## HISTORIC AND DESIGN REVIEW COMMISSION

June 06, 2018

**HDRC CASE NO:** 2018-230  
**ADDRESS:** 321 BRAHAN BLVD  
**LEGAL DESCRIPTION:** NCB 3855 BLK 1 LOT 22 AND 23  
**ZONING:** RM-4,NCD-9, H  
**CITY COUNCIL DIST.:** 2  
**APPLICANT:** Julie Gibson  
**OWNER:** Julie Gibson/Gibson Trust  
**TYPE OF WORK:** Rear Garage Modifications  
**APPLICATION RECEIVED:** May 09, 2018  
**60-DAY REVIEW:** July 8, 2018

The applicant is requesting a Certificate of Appropriateness for approval to modify the existing garage. Within this request, the applicant has proposed the following:

3 NORTH ELEVATION

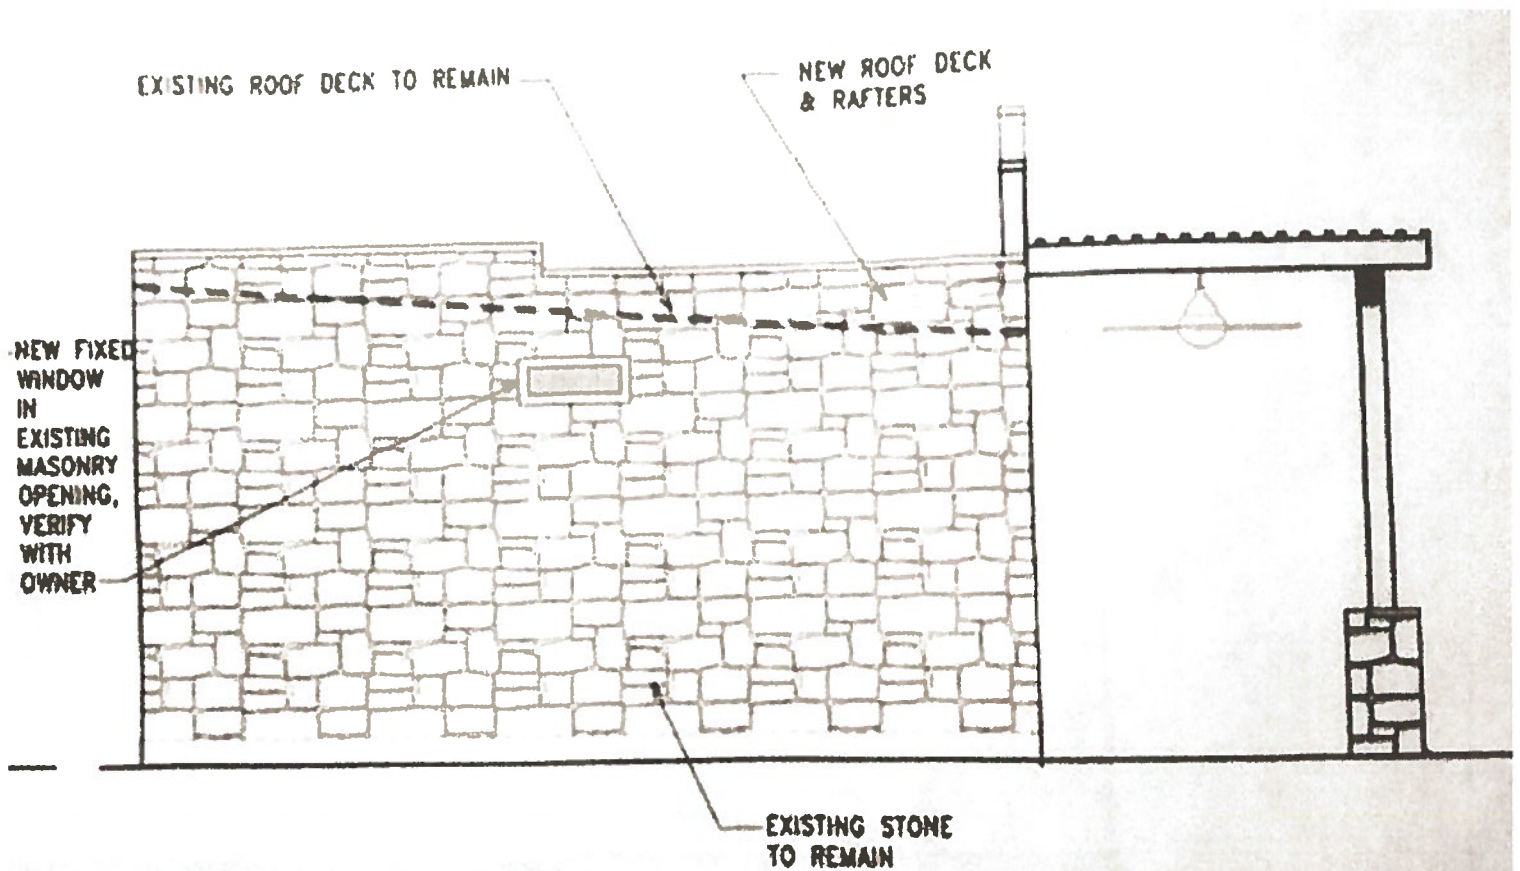
- c. **SIDE FACADES** – The applicant has proposed to install one new window in each the north and west facades as well as new window openings in the east façade. Per the construction documents, these windows will be fixed. Given their location on walls adjacent to property lines or rear alleys, staff finds the proposed size of the windows to be appropriate; however, staff finds the installation of windows that match those found on the historic structure to be most appropriate.

- i. That all windows installed feature an installation depth as well as material that match those found in the primary historic structure. Staff finds wood or aluminum clad wood windows to be most appropriate.
- ii. That the proposed stucco finish match that found on the primary historic structure.
- iii. That the proposed columns and column bases match those found historically on the rear porch of the primary historic structure.
